Addendum 5

Sugarcreek Water Treatment Plant and Wellfield Improvements

Addendum No. 5
June 1, 2022

FLUORIDE BUILDING
PROCESS
PLAN-SECTIONS

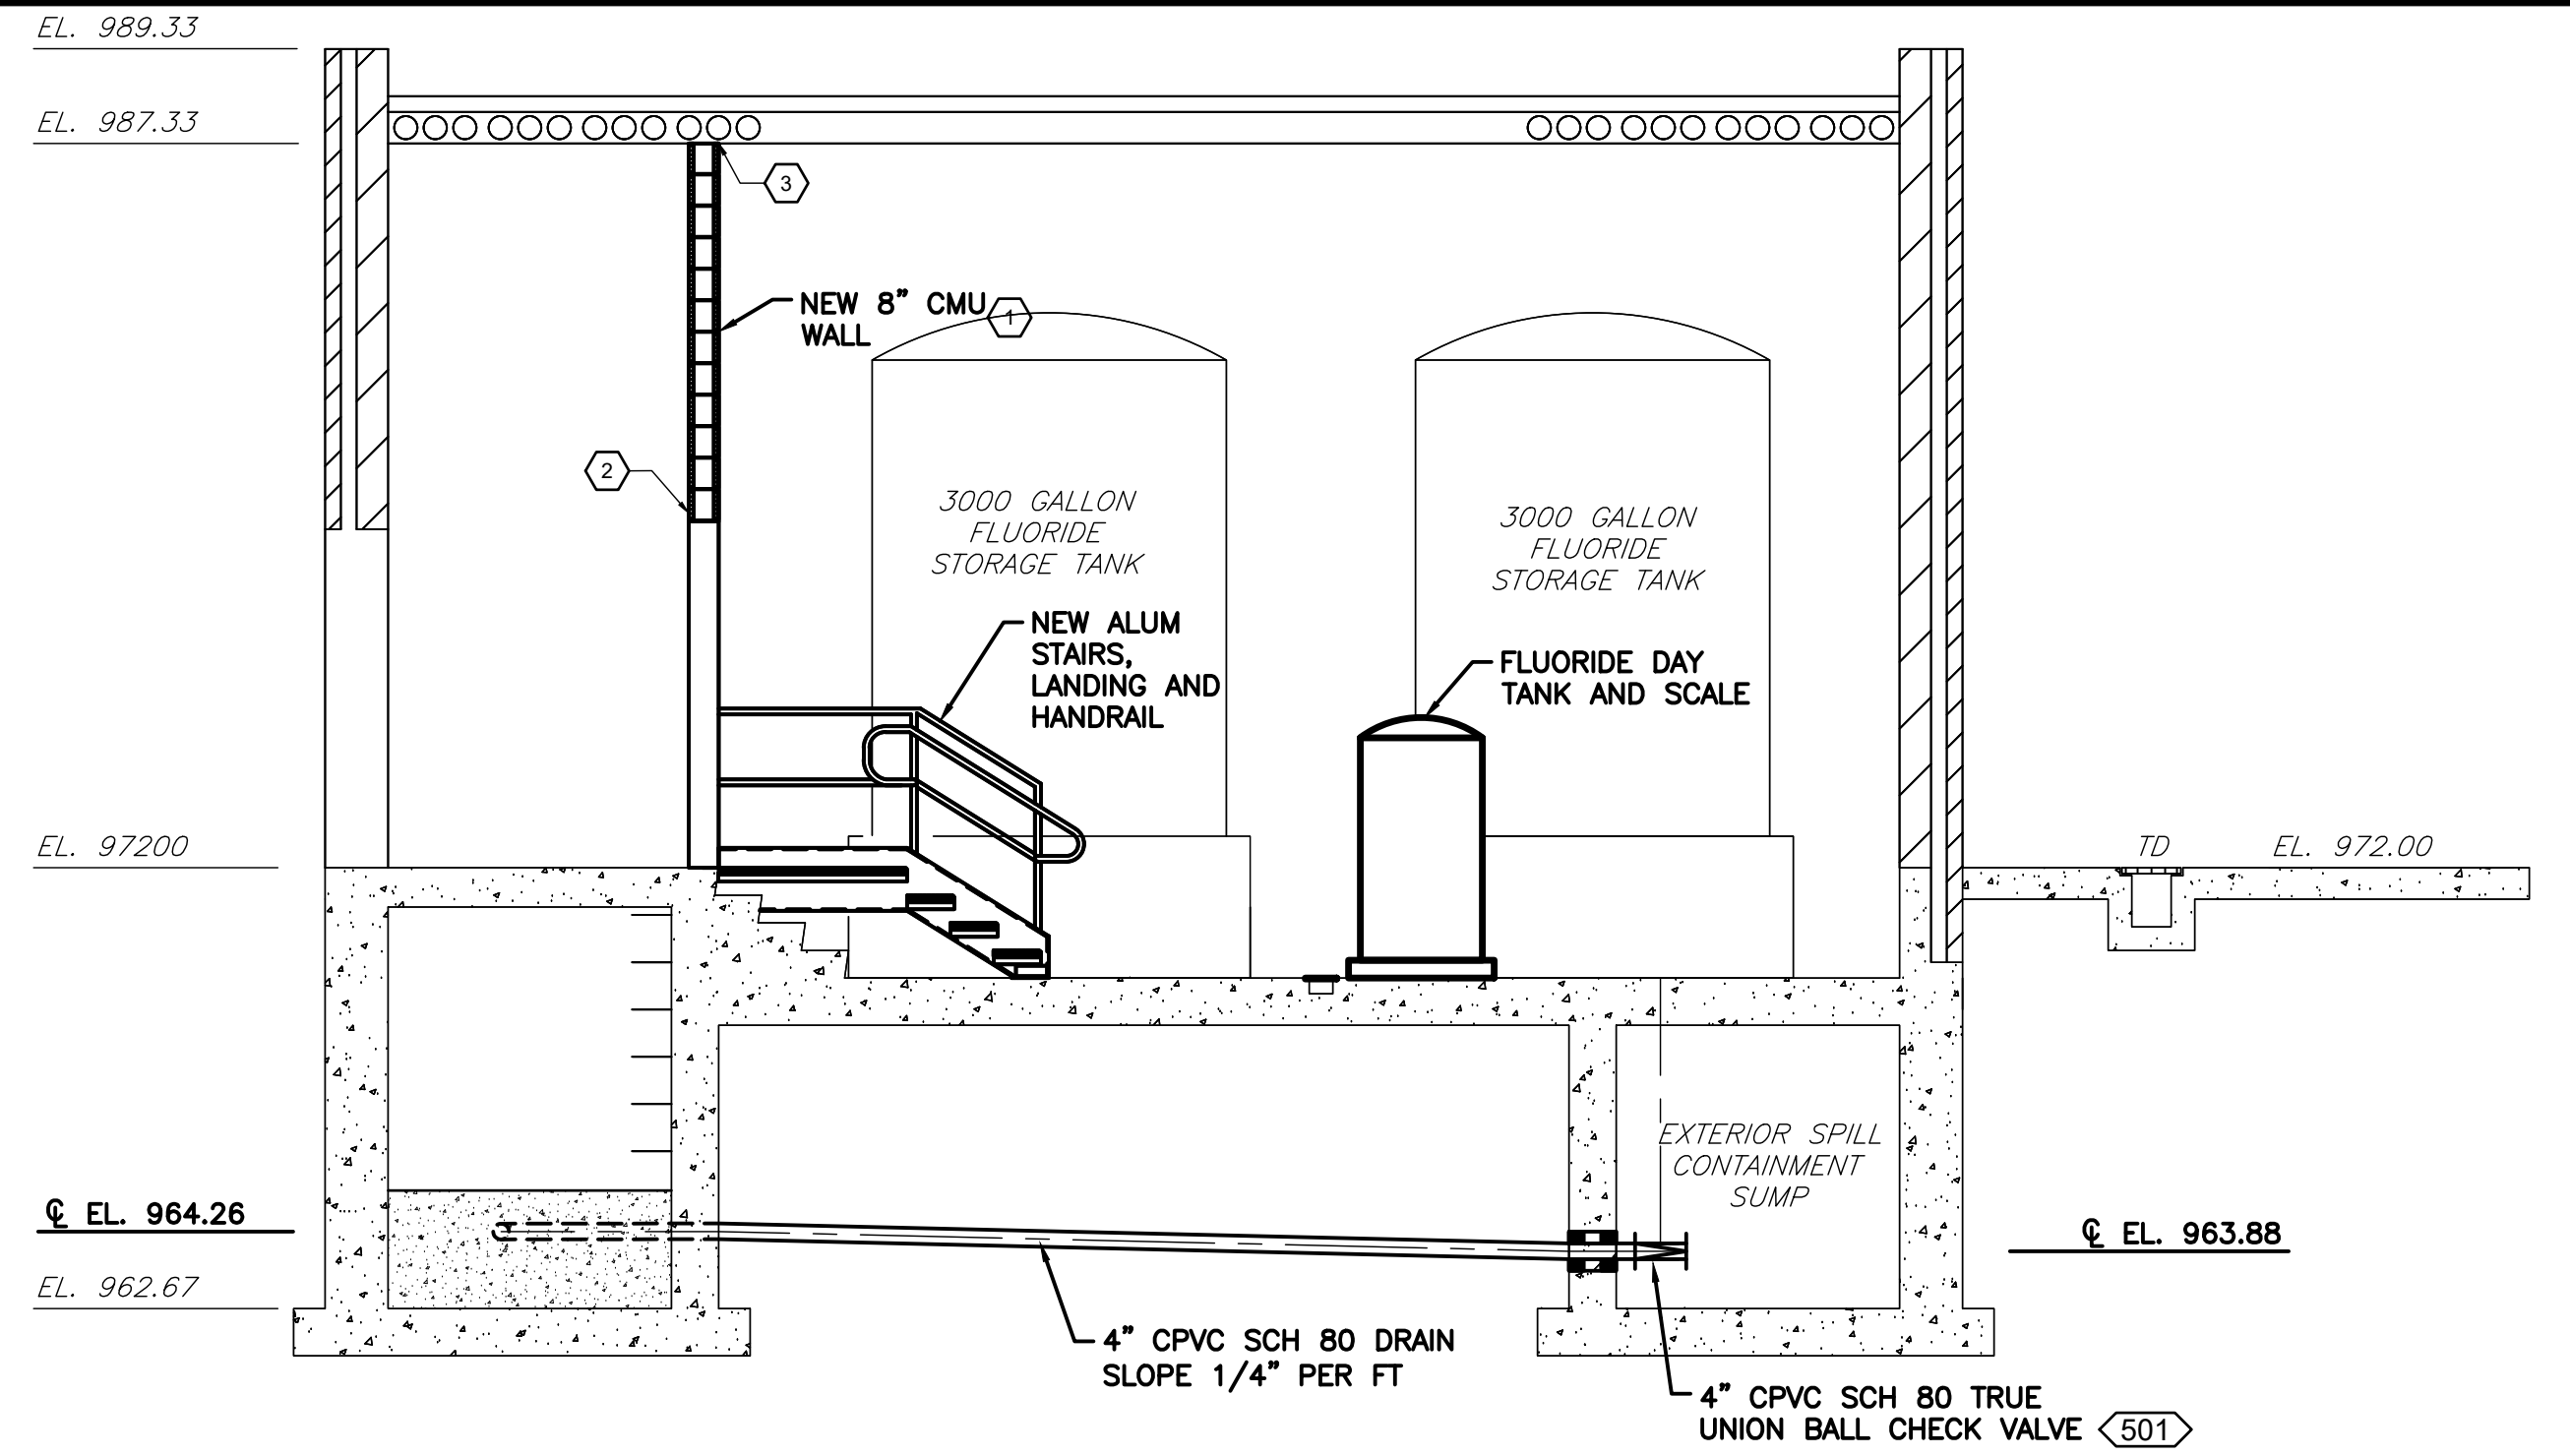
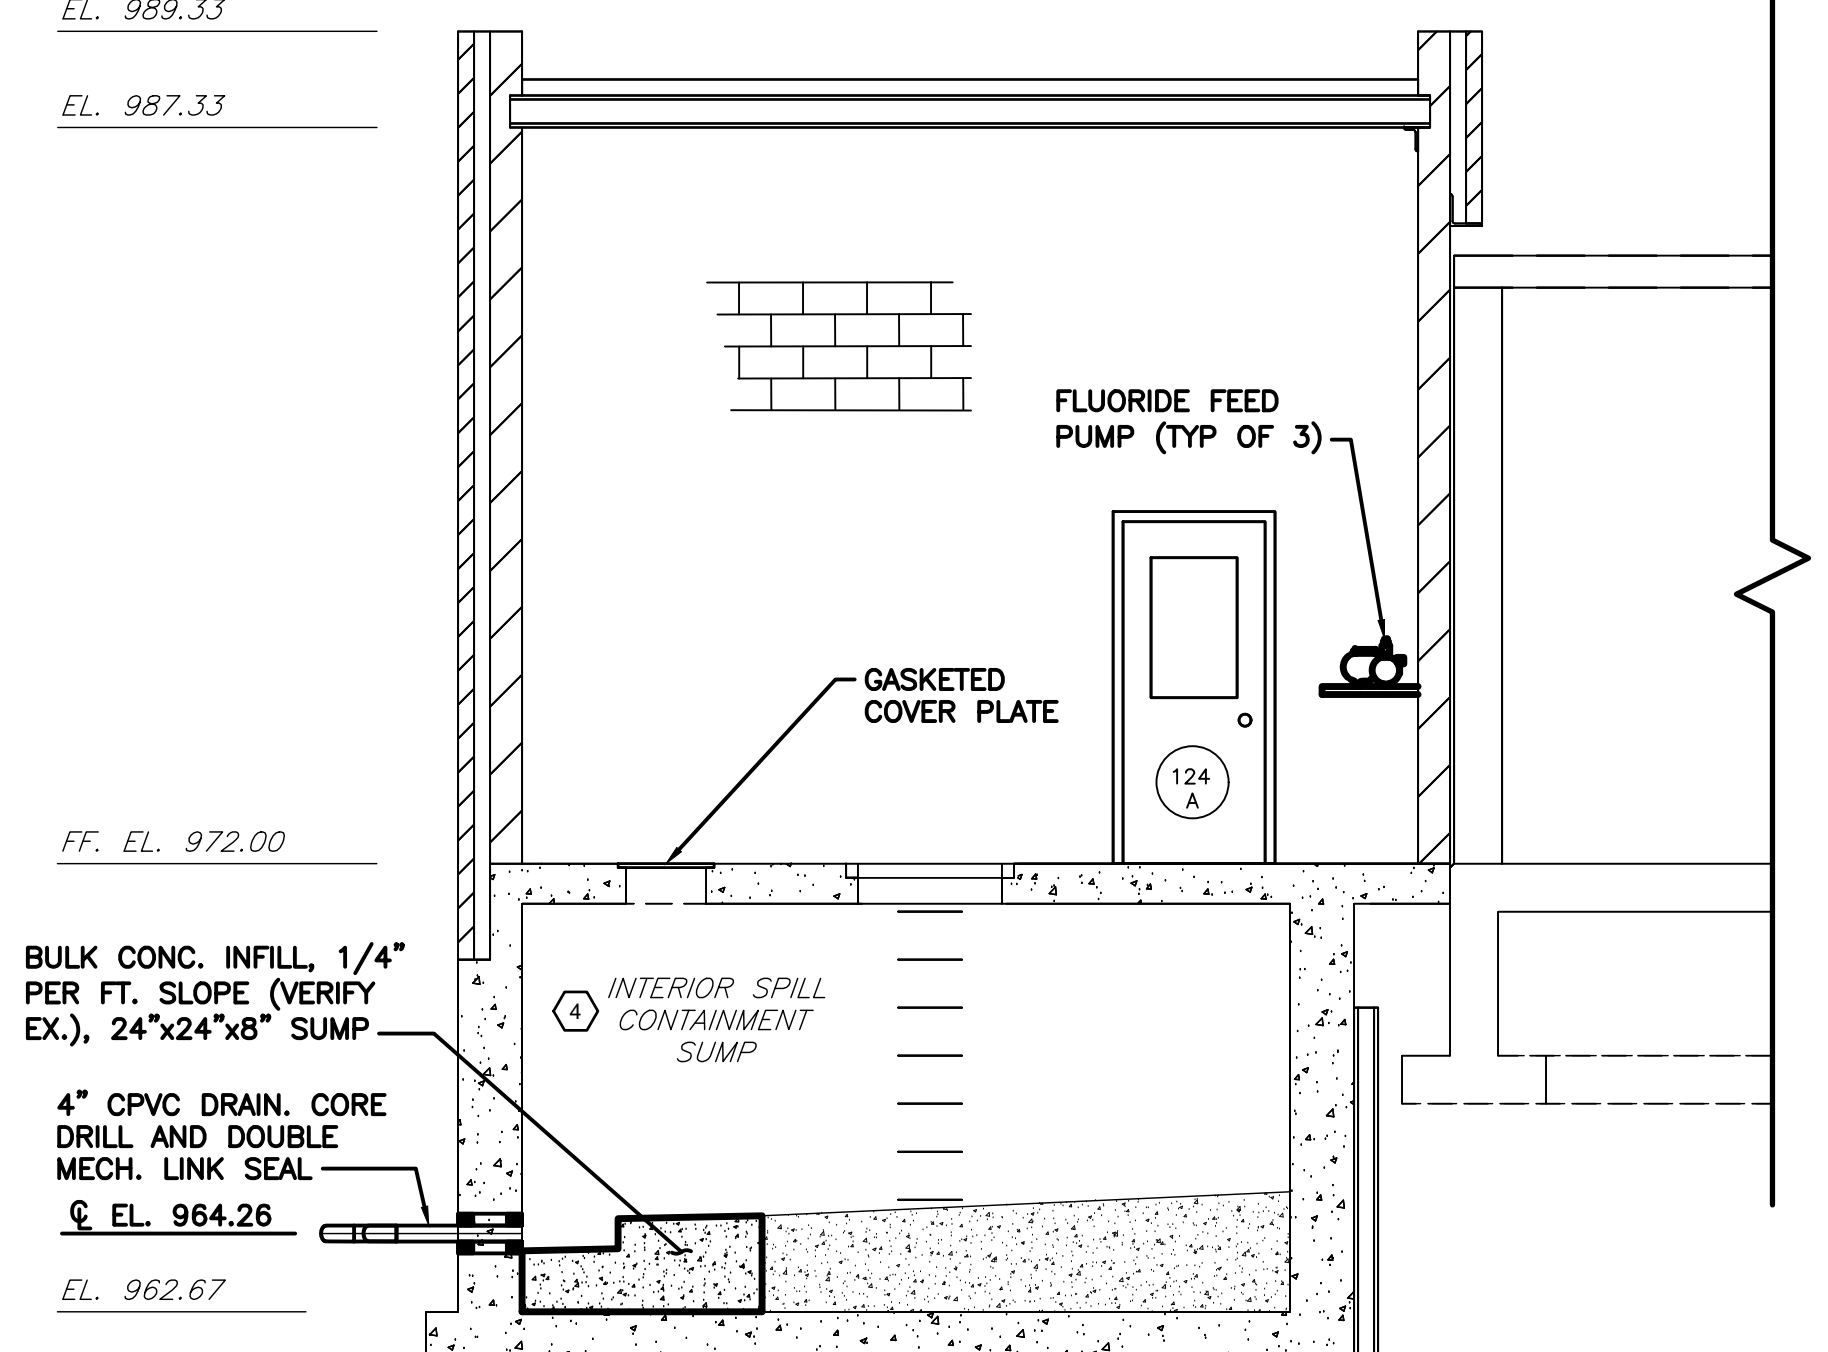
- Part 3.5 D. 27. Site Work at Main Water Treatment Plant. After paragraph 27. y, ADD “z. Remove and replace existing motor operated 3-way Plug Valve in manhole east of Fluoride Building serving Fluoride fill station drain. As shown on P-35 and E-61.”

- Blower Schematic, Note G for ASB-475 ADD “Valve shall be flanged per Valve Schedule.”
27. **Sheet P-35, Fluoride Building Process Plan-Sections.** REPLACE with the attached P-35. Revisions were made to show new stair as FRP instead of Aluminum, added details for replacing existing 3-way plug valve (500), and added information for new Fluoride Containment Drain Valve (501).
